# BCA Assessment Report

Schematic Design – REF Submission  
World Class End of Life Program  
Orange Hospital

**Revision 4**  
03 June 2024  
Reference: 230298

Figure No. 3: Existing fire and smoke compartment that the proposed inpatient unit is to be located within

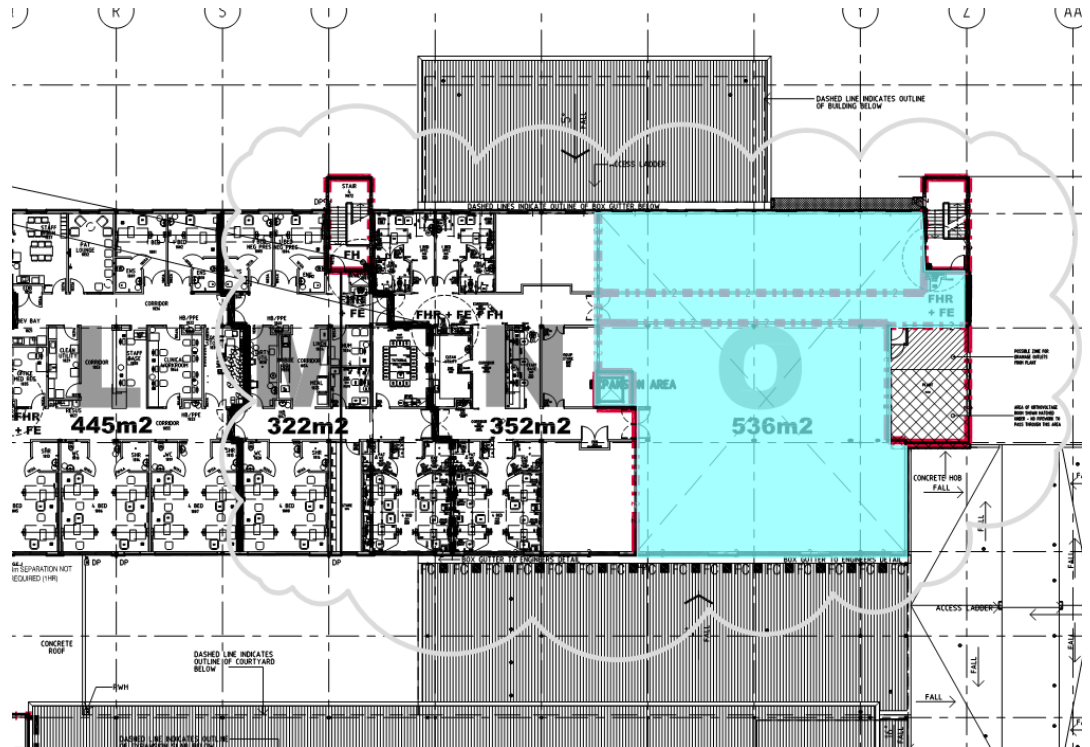
The fire compartment has a total floor area of 536 m<sup>2</sup> as detailed in the figure below.

The fire compartment size complies with the DTS Provisions of the BCA along with the size of the smoke compartment.

*Note: The courtyard area has not been calculated as part of the smoke compartment size, however, is included as part of the fire compartment size as a result of the courtyard being covered.*

Figure No. 4: Existing plant room fire separated from the proposed inpatient unit

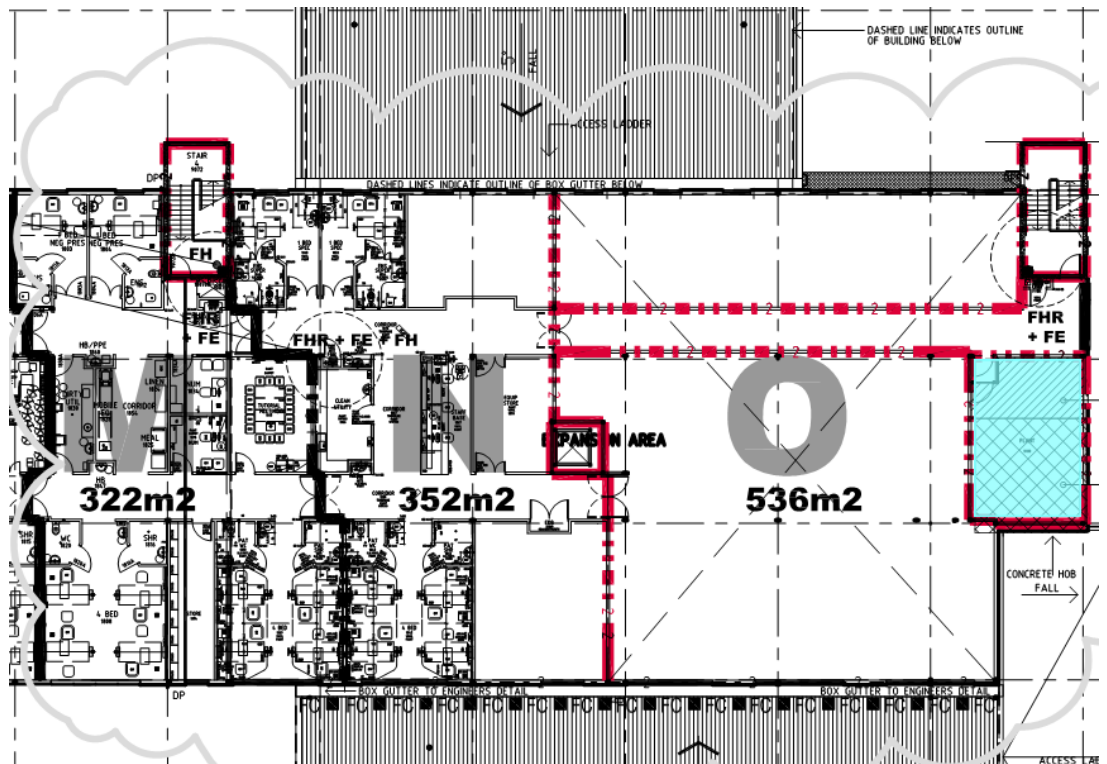
- + Ancillary use spaces are required to be 1-hour fire separated from patient care areas. Ancillary use spaces in a Class 9a comprise:
  - A kitchen and related food preparation areas having a combined floor area of more than 30m<sup>2</sup>.
  - A room containing a hyperbaric facility.
  - A room used predominately for the storage of medical records having a floor area of more than 10m<sup>2</sup>.
  - A laundry, where items of equipment are the type that are potential fire sources (e.g., gas fire dryers).

The Fire Compartment Drawing for Level 1 indicates that the existing Plant Room is fire separated from the proposed inpatient unit as detailed in the figure below. Verification is required that the existing Plant Room is also smoke separated from the proposed Ward Area.

Figure No. 5: Existing fire wall to be inspected and verified as being constructed in accordance with the DTS Provisions of the BCA

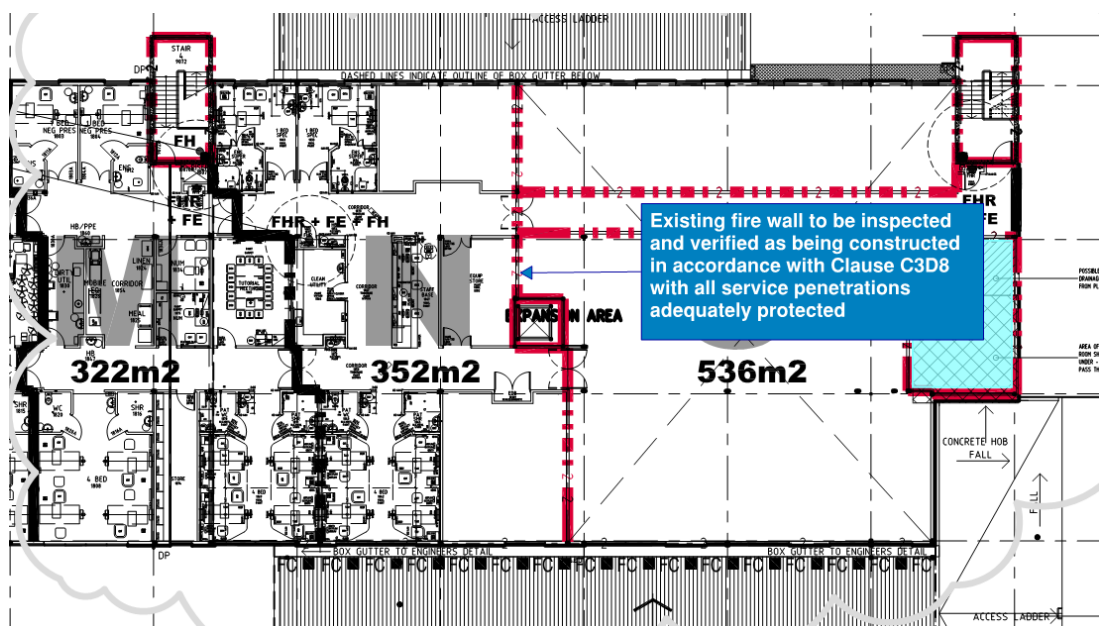
The existing fire wall separating the cold shell which will contain the proposed refurbishment area from the existing building will be required to be inspected and verified as being constructed in accordance with the provisions of Clause C3D8 including an FRL of 120/120/120

Any deficiencies in the fire wall with regard to construction and protection of service penetrations will be required to be upgrade as part of the proposed redevelopment works.

Figure No. 6: Existing fire safety door located within Level 01

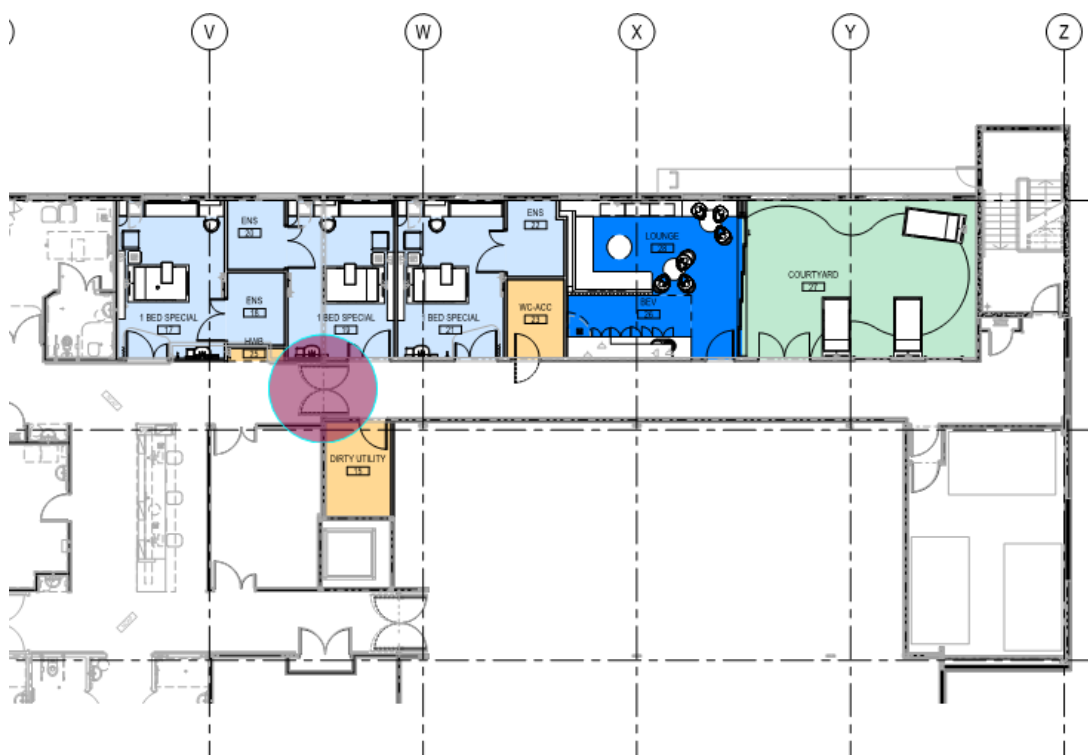
Verification will be required as to whether the existing fire / smoke door separating fire compartments swing in both directions or is a single swing door only.

If the door is single swing only, it will be required to be addressed as part of a Fire Engineering Performance Assessment to be undertaken by the appointed Fire Safety Engineer in order to demonstrate compliance with the nominated Performance Requirements of the BCA.

Figure No. 12: Existing horizontal exit door located within Level 01

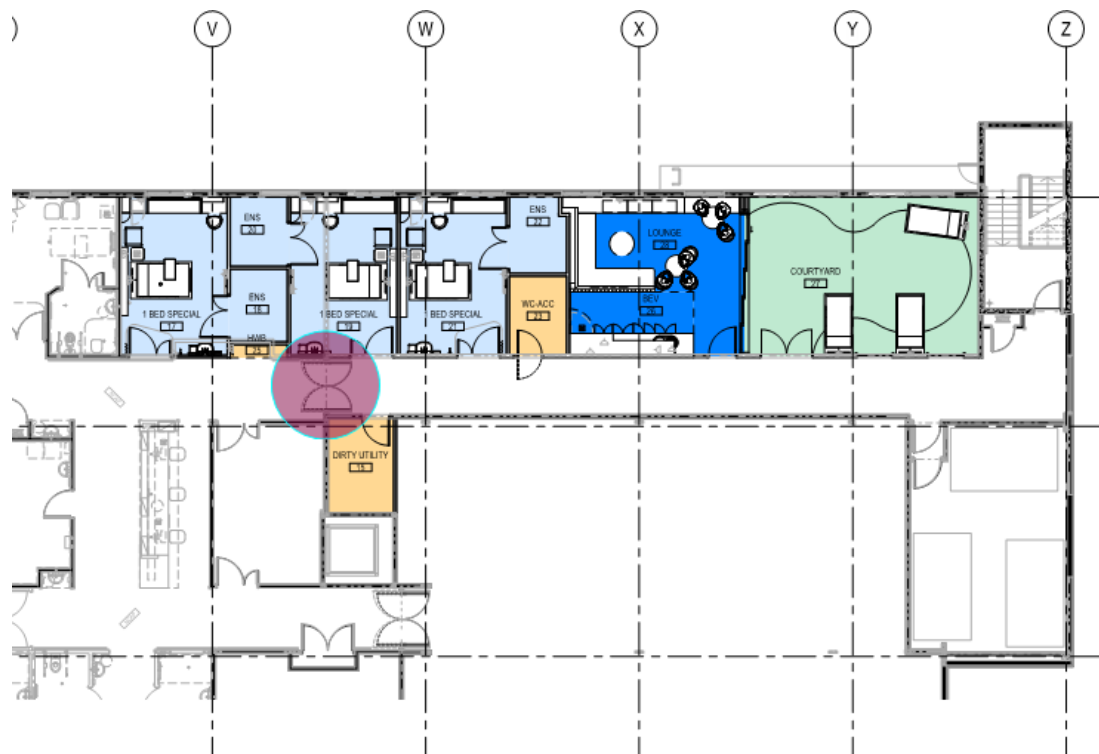
Verification will be required as to whether the existing horizontal exit doors fire compartments swing in both directions or is a single swing door only.

If the door is single swing only, it will be required to be addressed as part of a Fire Engineering Performance Assessment to be undertaken by the appointed Fire Safety Engineer in order to demonstrate compliance with the nominated Performance Requirements of the BCA.

Figure No. 25: Proposed unisex accessible sanitary facility

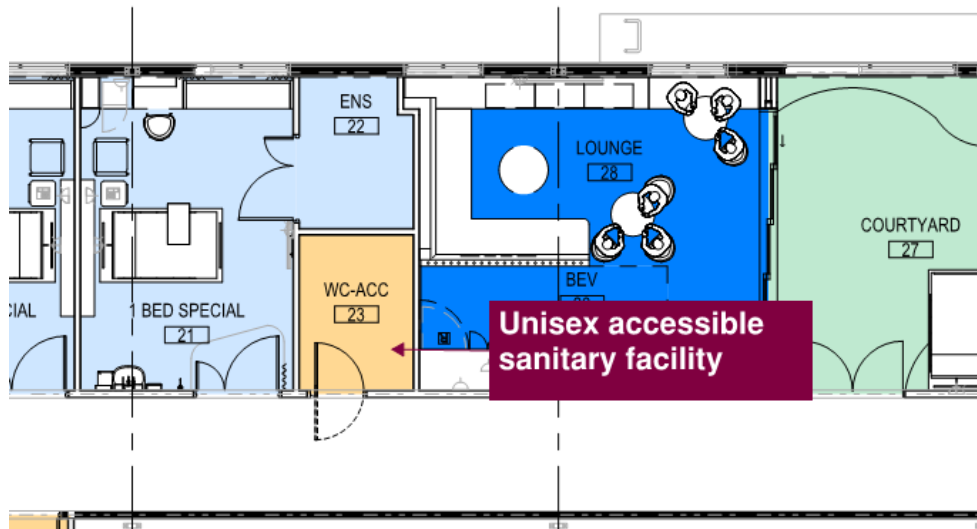
A unisex accessible sanitary facility is required to be provided on the storey for a person with a disability.

The Schematic Design Architectural Drawings indicate the provision of a unisex accessible sanitary facility for a person with a disability.
